Cobra 40X; "Card Kit-A" Installation

by T.S.

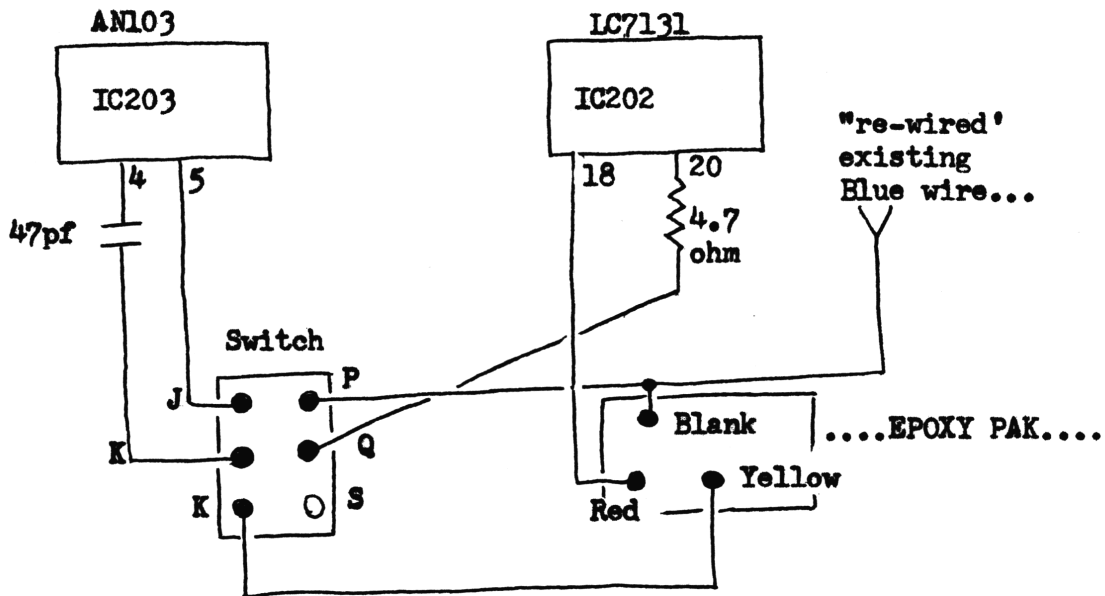
1. Unsolder Blue wire from Pin 20 of IC202.
2. Re-solder Blue wire to terminal P on switch, and Blank terminal on epoxy pak.
3. Add a 4.7 ohm resistor from Pin 20 of IC202 to terminal Q on switch.
4. Remove C320 from contacting Pin 4 of IC203.
5. Replace C320 to Pin 5 of IC203.
6. Install 47pf from Pin 4 of IC203, to terminal K on switch.
7. Wire from Pin 5 of IC203 to terminal J on switch.
8. Wire from terminal L of switch to Yellow terminal on epoxy pak.
9. Wire from terminal S of switch to D.C. ground.
10. Wire from pin 18 of IC202 to Red terminal on epoxy pak.

SEE DRAWING BELOW.....

Retune TX/RX circuitry for full coverage.....
